# CITY OF ALBUQUERQUE

September 6, 2017

**RE: Lot 5 Block 10 Unit 5 Volcano Cliffs SAD 227  
7905 Marigold NW  
Grading and Drainage Plan  
Engineers Stamp Date 8/31/17 (E10D35)**

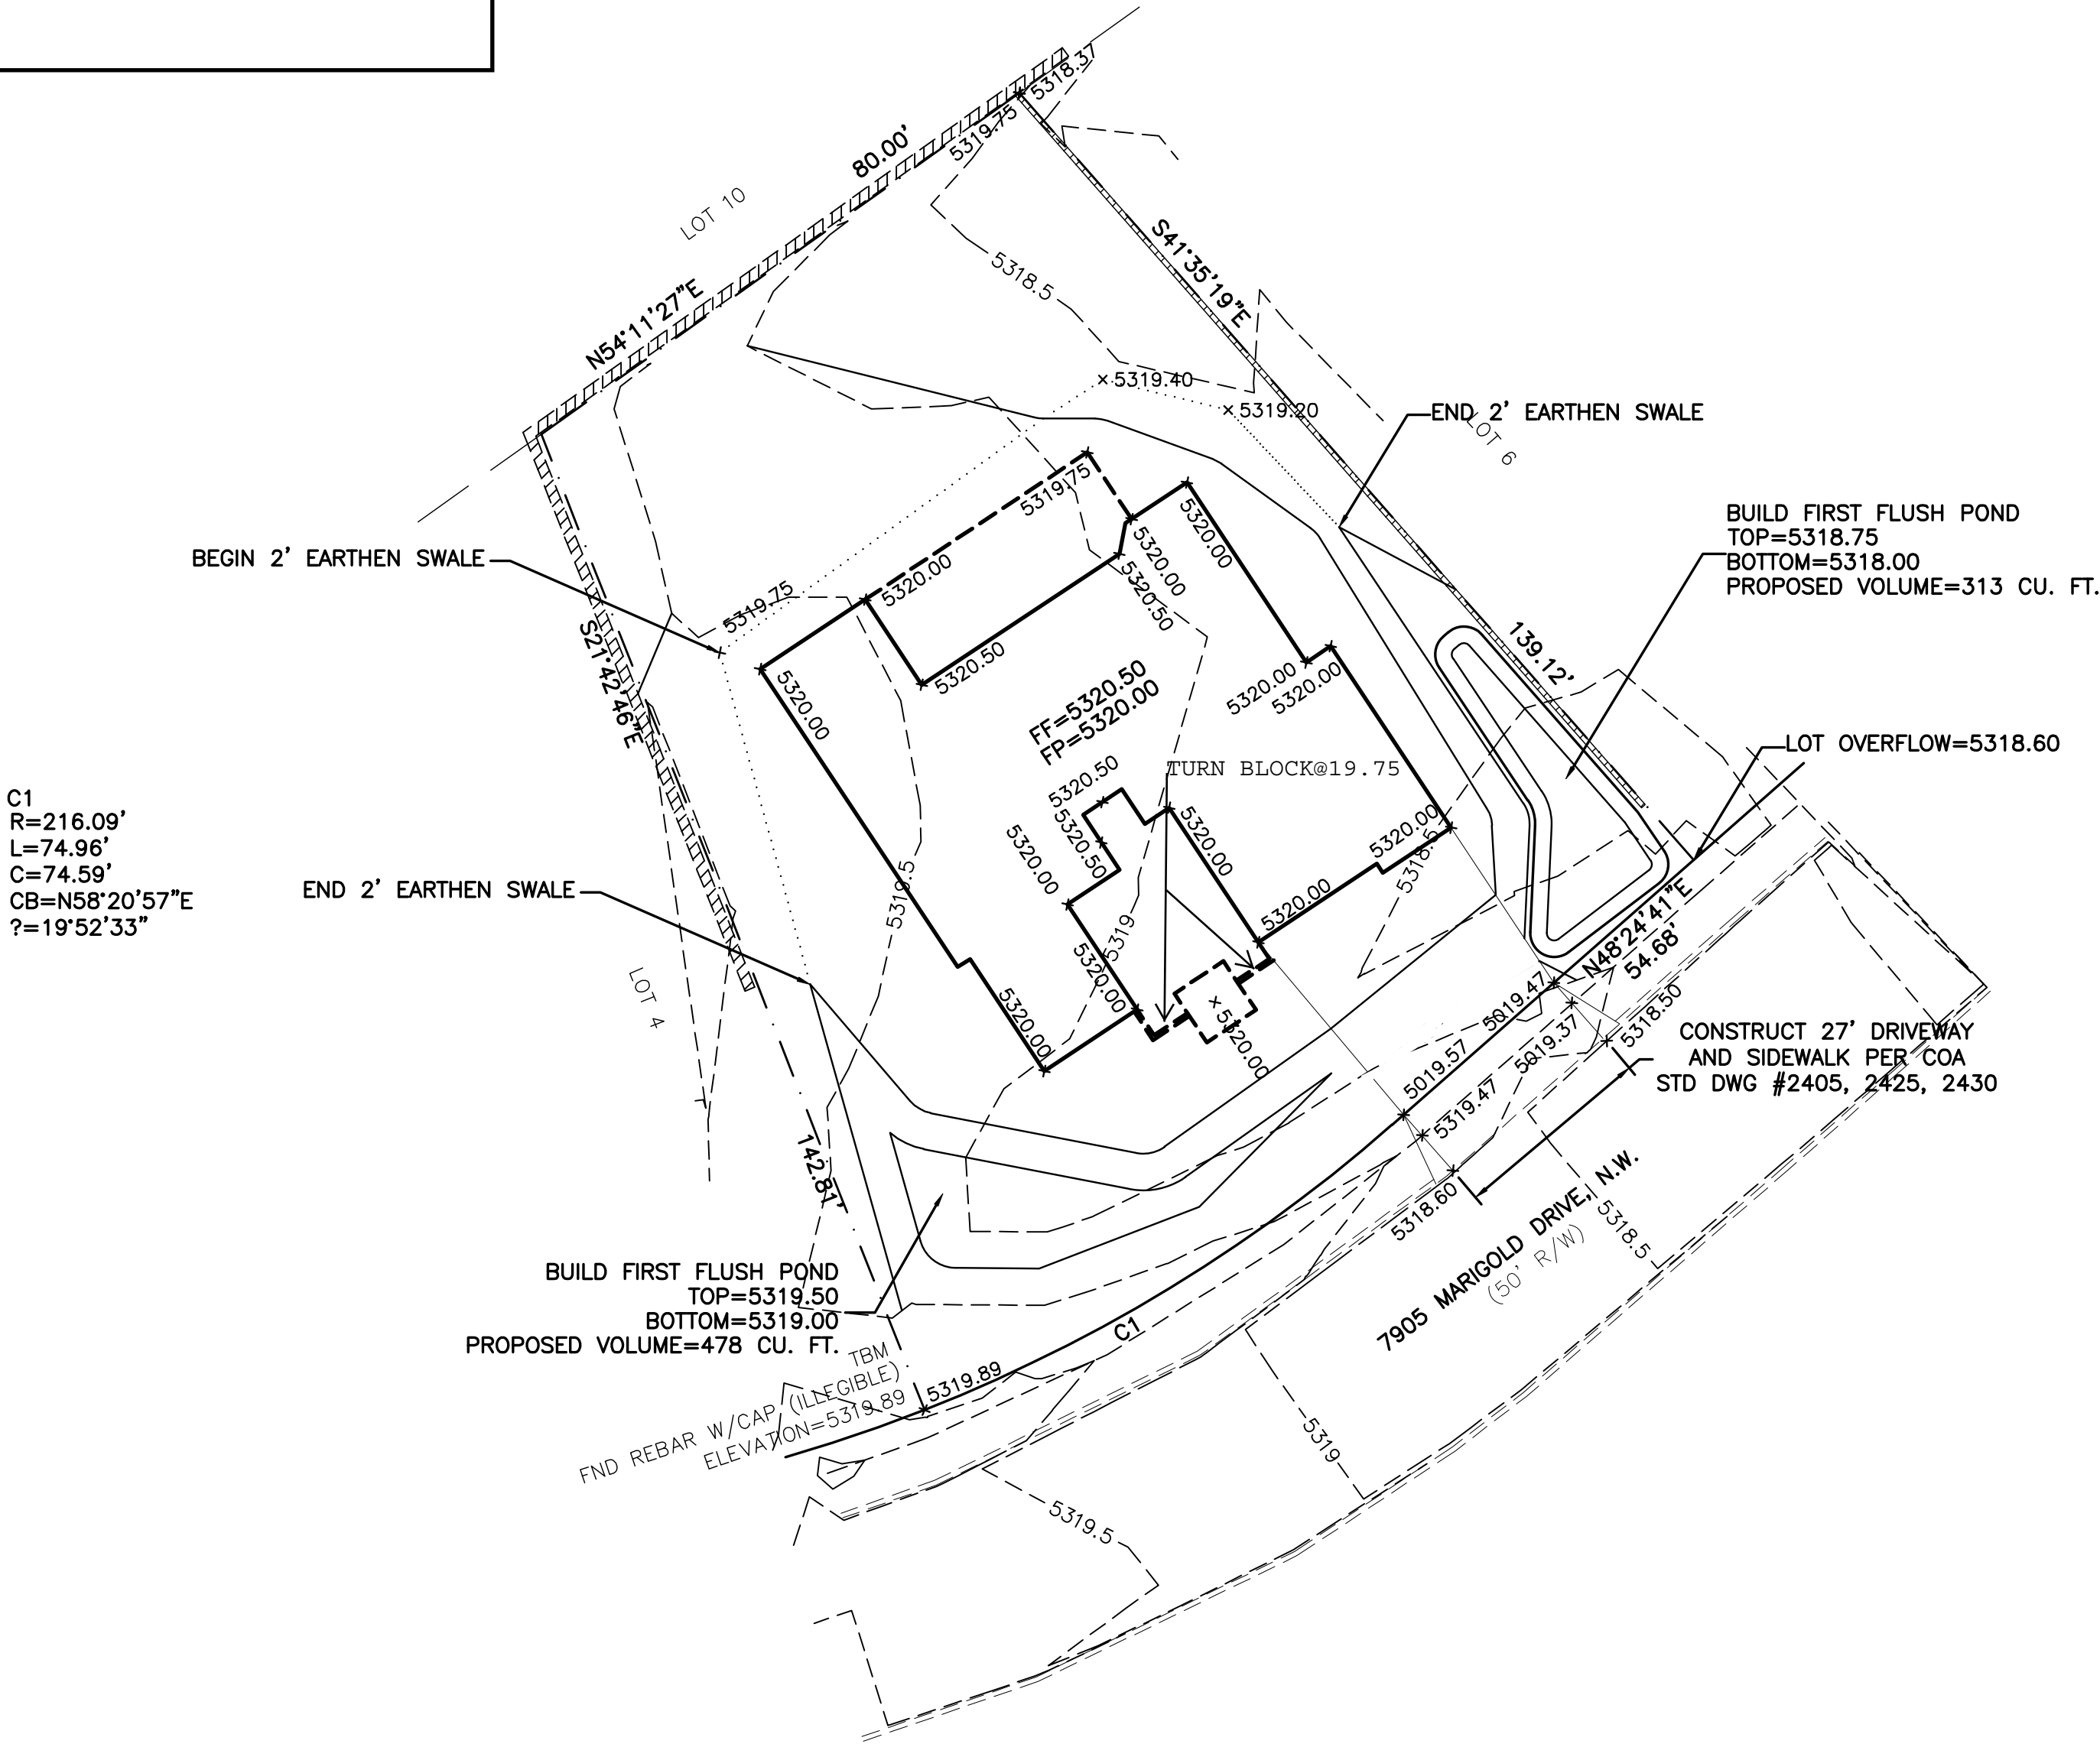
Based upon the information provided in your submittal received 8/31/17, this plan is approved for Grading Permit.

Reiterate to the Owner/Contractor that a separate permit for a garden/retaining wall must be obtained, with the approved G&D plan dated 8/31/17.

Prior to Building permit approval a Pad Certification will be required, provided by the Engineer or a registered Land Surveyor.

Prior to Certificate of Occupancy release, Engineer Certification per the DPM checklist of this plan will be required.
